**Project:** MD-124 (Woodfield Road) Extended, MR-01805-DPWT-1 from  
North of MD108 to MD27

**Review Type:** Final Forest Conservation Plan

PROJECT: Woodfield Road Extended  
CIP Project No.500151

REVIEW TYPE: Mandatory Referral No. MR# 01805-DPW&T-1

**RIDGE ROAD**  
Typical Two-Lane Section

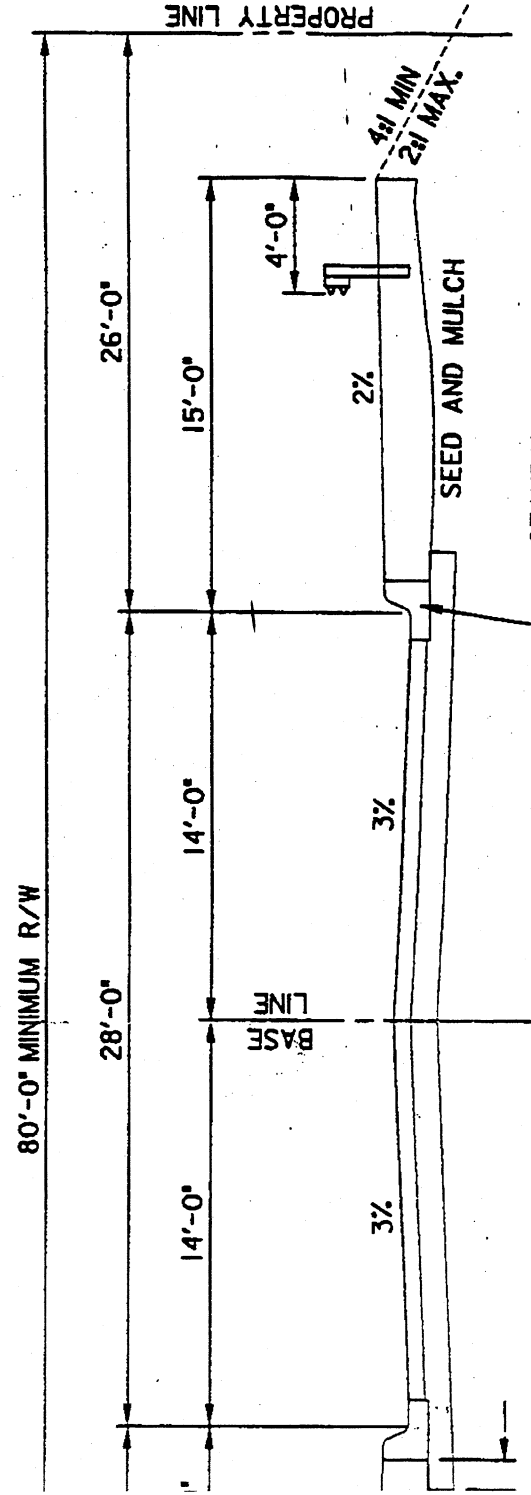
Twelve-foot travel lanes and four-foot shoulders would be provided in the reconstructed area of Ridge Road (see Attachment 4a). The proposed shoulders will provide a measure of safety for drivers and will accommodate on-road bicycle use.

The proposed intersection of Ridge Road and Woodfield Road Extended will define the border between the northern edge of Damascus and the more rural area of the agricultural reserve. While maintaining the existing open-section roadway is preferred, vertical face concrete curb is proposed through this area to limit impacts on adjacent residences. Beyond a concern that vertical face curb is an urban material that would seem inappropriate in this area, staff is also concerned that it may not reflect how people drive through this area. Vertical face curb is not recommended by the American Association of State Highway and Transportation Officials (AASHTO) for higher speed areas because of the chance that an errant vehicle could vault the curb.

While the posted speed of Ridge Road north of the intersection is anticipated to continue to be 40 mph, the proposed improvements to the alignment of the road may mean that the number of vehicles going faster than the speed limit may increase. *Staff recommends that the installation of a mountable curb be considered on Ridge Road north of the proposed intersection with Woodfield Road Extended.* South of the intersection, where the existing posted speed of 30 mph is anticipated to remain, there is not the same concern that vehicles will vault the curb.

The installation of curbs is proposed along this segment of Ridge Road, but normally where we have curbs, we also construct sidewalks and plant street trees. None are proposed in the current plans, however. *South of the proposed intersection, staff recommends that sidewalks be installed on both sides of Ridge Road. North of the intersection, headed toward the rural area, staff recommends that an off-road bike path be constructed on the east side of Ridge Road, a location that will tie well into the proposed bikeway on the north side of Woodfield Road Extended.*

**WOODFIELD ROAD EXTENDED**  
Three-Lane Section at Northern End

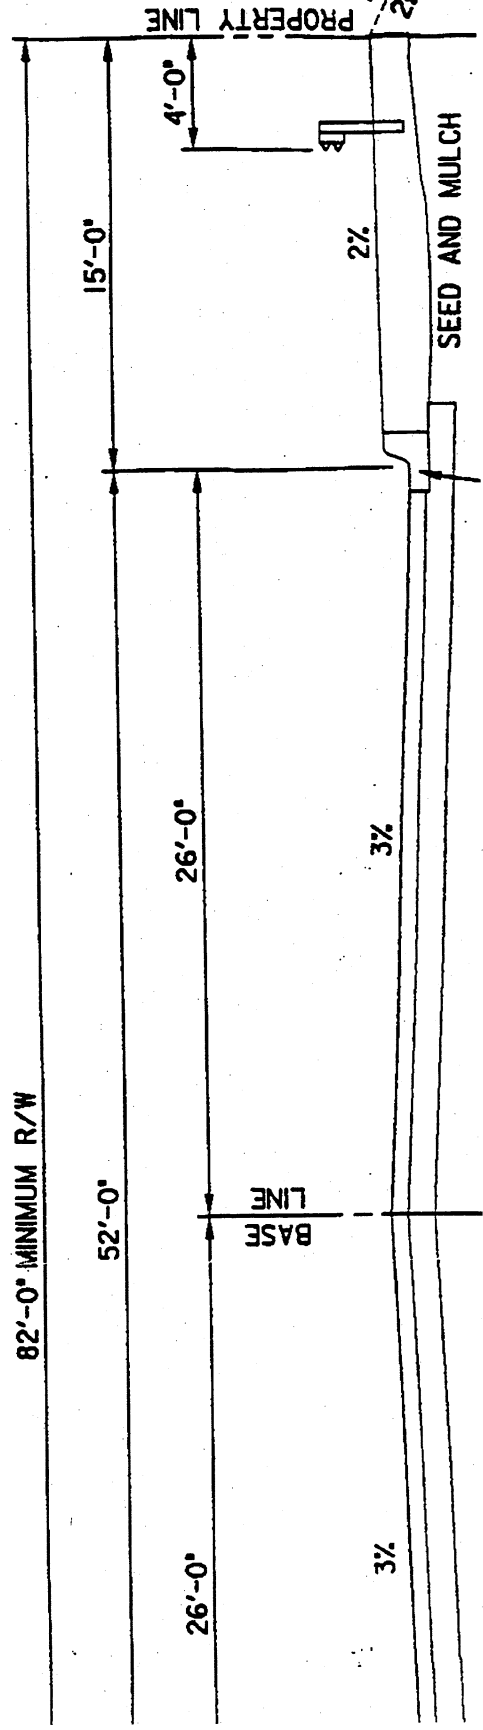
The County standard for a closed-section arterial road includes eight-foot landscape panels. The Project Prospectus also included eight-foot landscape panels, but the current design includes only six-foot landscape panels (see Attachment 4a). While six-foot panels are the County's minimum width to support the planting of street trees, eight feet would be better for the health of the trees and would provide a better offset for pedestrians and bicyclists on the sidewalk and bike path, particularly given that the previously planned on-road bike lanes, which would have provided greater separation of vehicles from pedestrians, will not now be built (see below). *Staff recommends that DPWT provide eight-foot landscape panels along Woodfield Road Extended where not constricted by wetlands or adjacent homes.*
